## Technical Memorandum

### Review of Draft Environmental Impact Statement, Proposed PennEast Pipeline, Docket No. CP15-558-000, FERC\EIS: 0271D

Prepared for: Delaware Riverkeeper Network

*Figure 3: National Wetlands Inventory map of the proposed PennEast Pipeline along the Aquashicola Creek.*

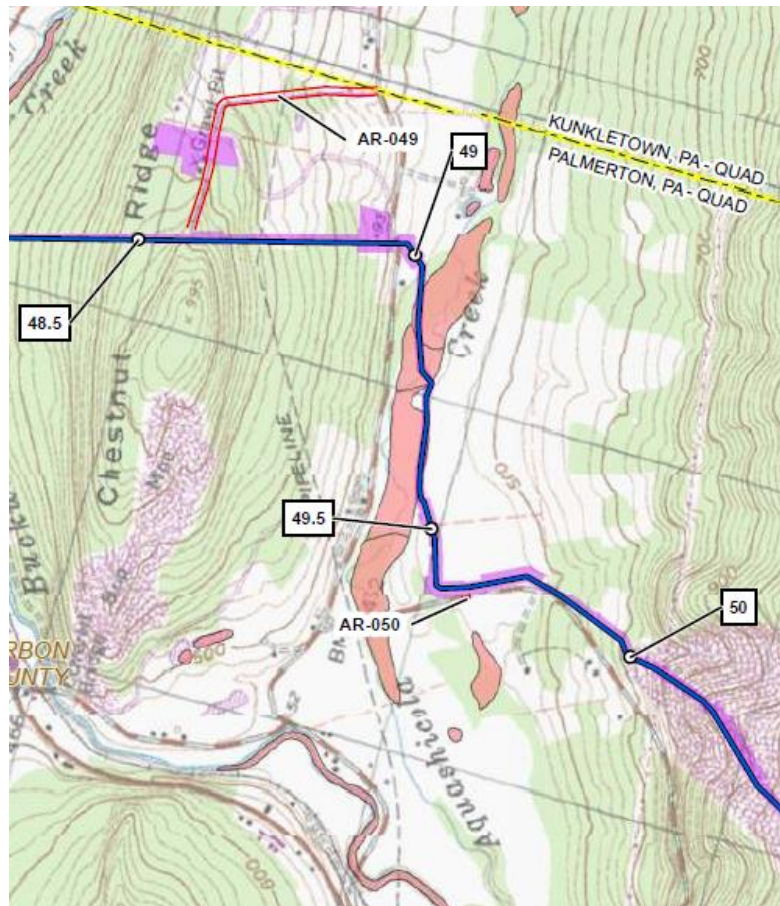
**Aquashicola Creek Crossing (MP 49 to 49.7):** The proposed preferred route crosses an extensive wetland and parallels Aquashicola Creek for more than half a mile (Figure 3). The proposed preferred route appears to almost maximize the amount of wetlands and floodplain affected by the pipeline. The pipeline crossing the floodplain could significantly divert groundwater flow and affect wetland water balances and baseflow in the creek. Direct impacts due to construction on the creek are also obvious. The values of the wetlands on the floodplain are obvious from a site visit, with Aquashicola Creek meandering through dense shrub/herbaceous vegetation (Photo 1).

- Penn East should consider extending the straight reach from MP48.5 to 49.0 another approximate 0.2 miles across the stream, floodplain, and wetlands prior to diverting southward. An obvious location for the new layout to intersect the pipeline would be at about MP 49.75 where the proposed pipeline changes direction to go southeast. This proposal would require negotiating a route through some Blue Mountain Ski Area facilities but this would be less environmentally damaging than the proposed layout. There would also be less potential for

construction to disturb polluted groundwater or aerially deposited sediments due to the Palmerton Zinc Pile Superfund Site (EPA 2011). There would be much less impact on wetlands and less direct stream crossing.

Figure 4: Snapshot of proposed pipeline near Monocacy and East Branch Monocacy Creek, near Bath, PA. MP 59.5 to 62.

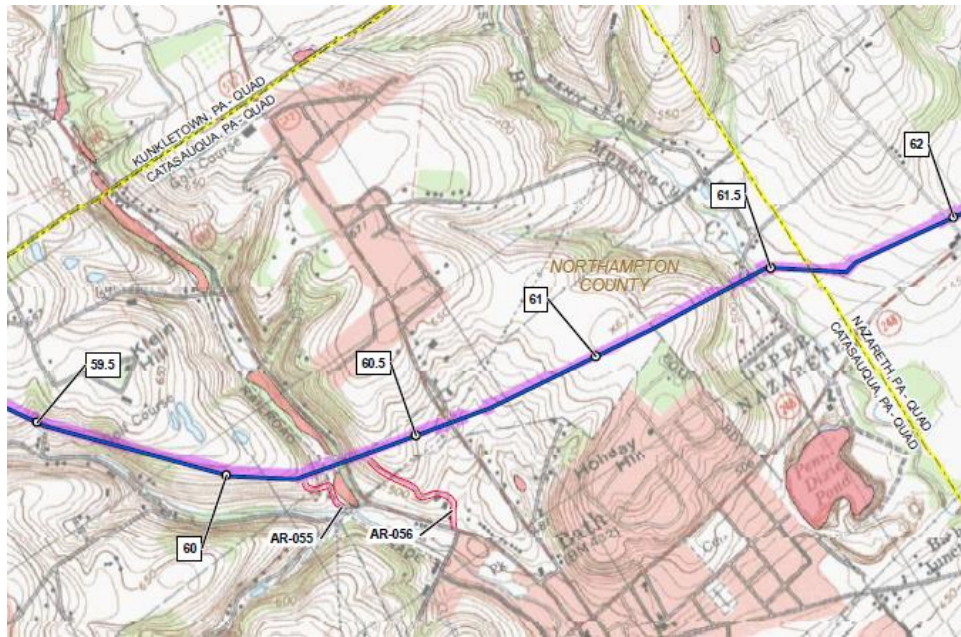
**Monocacy Creek, MP 60.0 to 60.5:** The pipeline in this vicinity would border on a steep slope southwest of Klein Hill (Figure 4) and crosses a broad floodplain with a small stream providing groundwater discharge to Monocacy Creek (Photo 2). The route avoids the White Tail golf course but in so doing it impacts the floodplain (Photo 2) thereby affecting groundwater discharge to Monocacy Creek. Its route along the steep slopes may also cause erosion or intercept groundwater flowing from Klein Hill to the Monocacy Creek tributary (Figure 4). The crossing of East Branch Monocacy Creek near MP 61.5 (Figure 4) also involves the pipeline cutting vertically down a steeper slope.

- Penn East should consider an alternative route through this area to improve the crossing of both creeks just mentioned. Directing the proposed route east across Klein Hill would miss wetlands. All potential routings in this vicinity are in need of greater consideration.

Figure 6: Map of wetland and topography near MP 29.6.

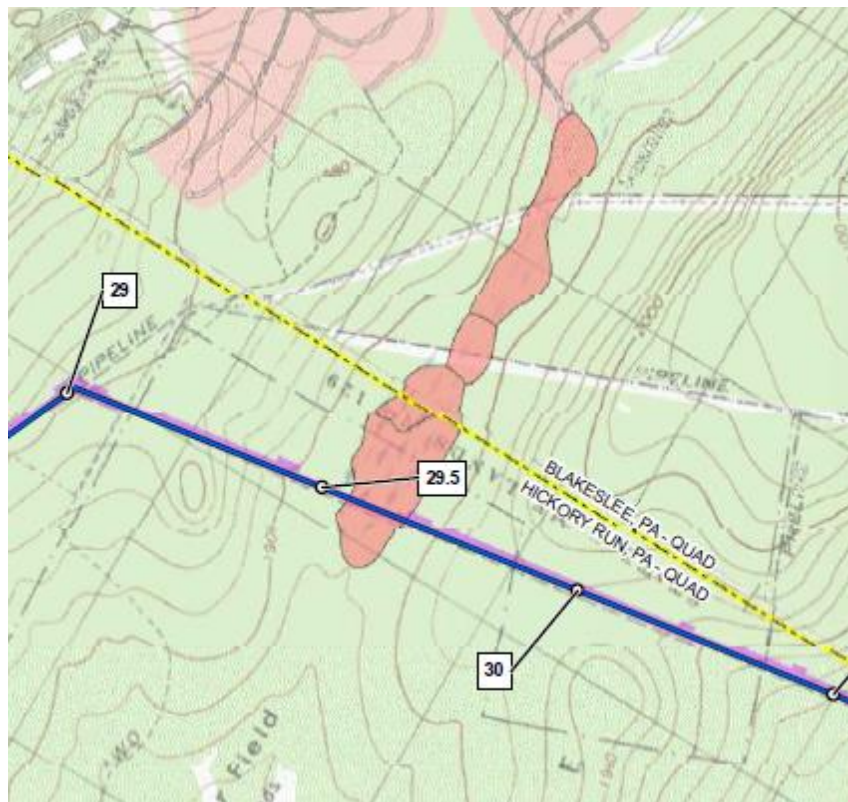
A good example occurs at about MP 29.6 where the pipeline crosses an existing wetland that depends on groundwater for support (Figure 6, Photo 5). There is no obvious surface water inflow, other than storm runoff (Figure 6). The wetland straddles a minor topographic divide, so the area supporting the south end of the wetland is limited. A trench that causes groundwater to surface could significantly change the water balance in the south end of the wetland thereby causing it to be lost due to indirect impacts - indirect being not direct construction but a loss of water.

- At wetlands like this, PennEast should consider whether a deeper boring could prevent indirect losses of wetlands. They should do this for all significant wetlands crossed by the proposed pipeline.

Figure 7: Snapshot of soils map (RR7, Figure 2.1-1) showing MP 7.0 to 10.0. Soil SM is strip mine.

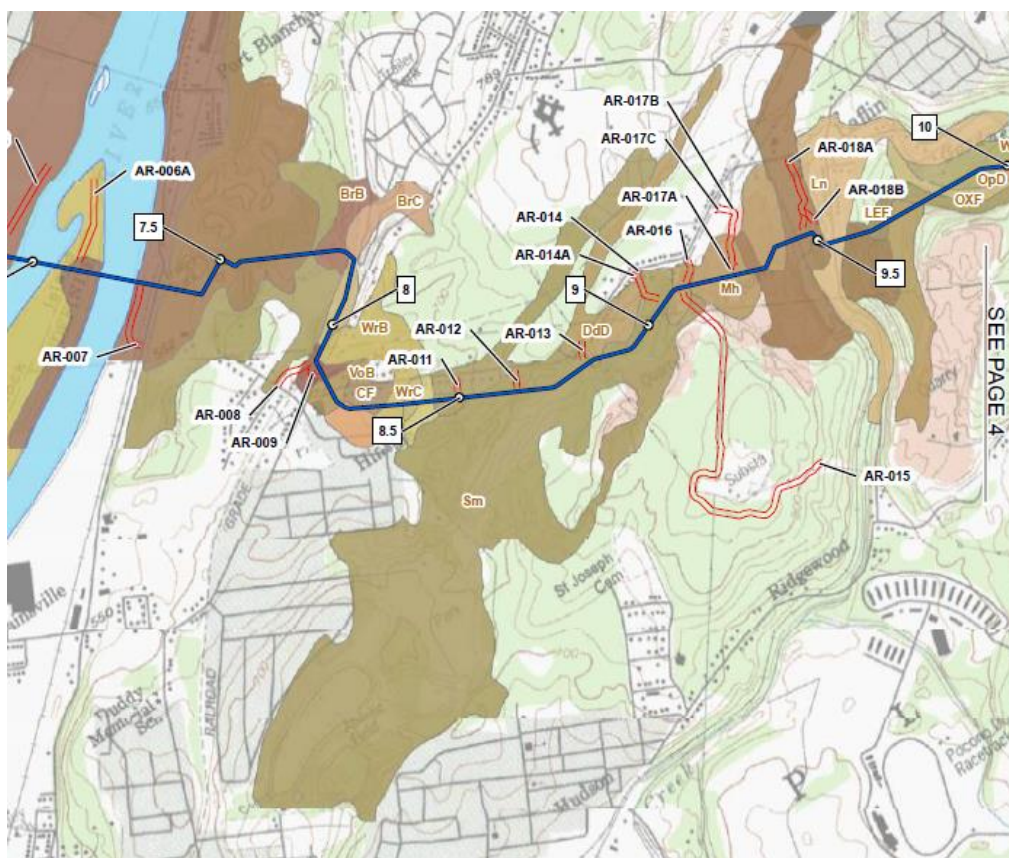
on Figure 7, mine-affected soils cover substantial areas on the east side of the Susquehanna River crossing. Excavating or otherwise disturbing mine spoil can release contaminants, including acid mine drainage (AMD) if sulfides are present. However, the DEIS does not present any discussion of minerals that could be present in these soils or discuss whether minerals or other contaminants including AMD could result from meteoric water leaching through or running off of these soils. The mine spoil identified in RR7 is considered to have high conductivity (RR7, Table 7.1-1 for Luzerne County), which means the potential for contaminants to be released by construction disturbance is relatively high. It also has the potential for high erosion when disturbed (RR7, p 7-16). But the DEIS fails to discuss the pollution potential that will result.

- The DEIS should include data or information regarding the mineral content of the soils to be crossed by the proposed pipeline and the results of leaching tests that should be required.
- The DEIS should assess the potential for pipeline construction to generate acid generation or leach metals in all areas where it crosses mine spoil.
- The DEIS should present avoidance and mitigation discussions focused on preventing the leaching and transport of acid and metals from the site.

Figure 9: Snapshot of wetlands map (RR1, Appendix D, p 9 of 32).

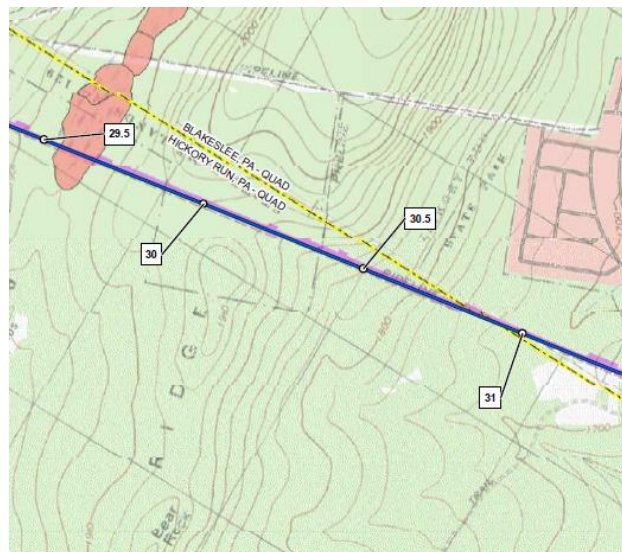
→ Starting at MP 29.5 is a series of high compactable soils through MP31.2 (Table 2 and Figure 8). This reach is generally up and down the slopes of a ridge in Hickory Run State Park so runoff would be straight downhill. The bedrock is Catskill Formation which has specific capacity from 0 to 43 gpm/ft (RR2 Figure 2.2-1) and very wide ranging well yields (Taylor 1984). Recharge varies from 20 to 22.2 in/yr in this area (RR2, Figure 2.2.4-1), so pipeline construction could reduce recharge (and inflow to the wetland) by as much as 4.4 af/y (0.006 cfs or 2.8 gpm). The bedrock properties control whether the lost recharge is shallow or deep. Based on the size of the wetland (Figure 9), the area affected by the pipeline appears to be a couple percent of its tributary area, but the effect of losing this amount of recharge would depend on the connectivity of parts of the wetland. Considering that compaction could reduce recharge up to 4.4 af/y through this reach, the DEIS must provide the detail necessary to adequately assess how the lost recharge will affect hydrogeology of the area. That missing information is an irreparable deficiency that can only be remedied by providing the data and analysis necessary to assess this impact.

Figure 12: Snapshot of soils map from MP 33.8 to 35.2 (RR7, Figure 7.1-1).

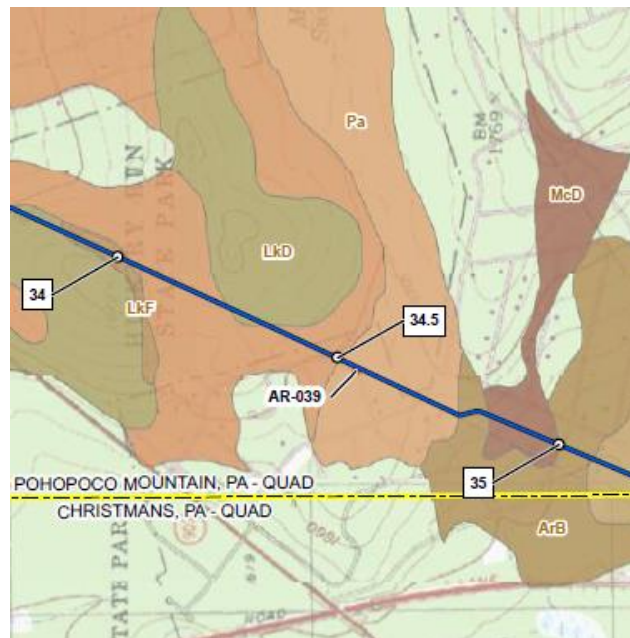
→ Compactible soils from MP 34.5 through 34.8 control drainage to both sides of a wetland at MP 34.6 (Figures 12 and 13). Compaction could eliminate up to 3 af/y of recharge (0.3 miles, 50 foot wide construction corridor, 20 inches/year recharge) that supports a wetlands approximately 3.3 acres (Figure 13) in size. As a result, the water balance of the wetlands would be considerably changed and the wetland would become highly vulnerable to and/or impacted by drought. This could significantly harm the wetland even if the compaction is temporary.
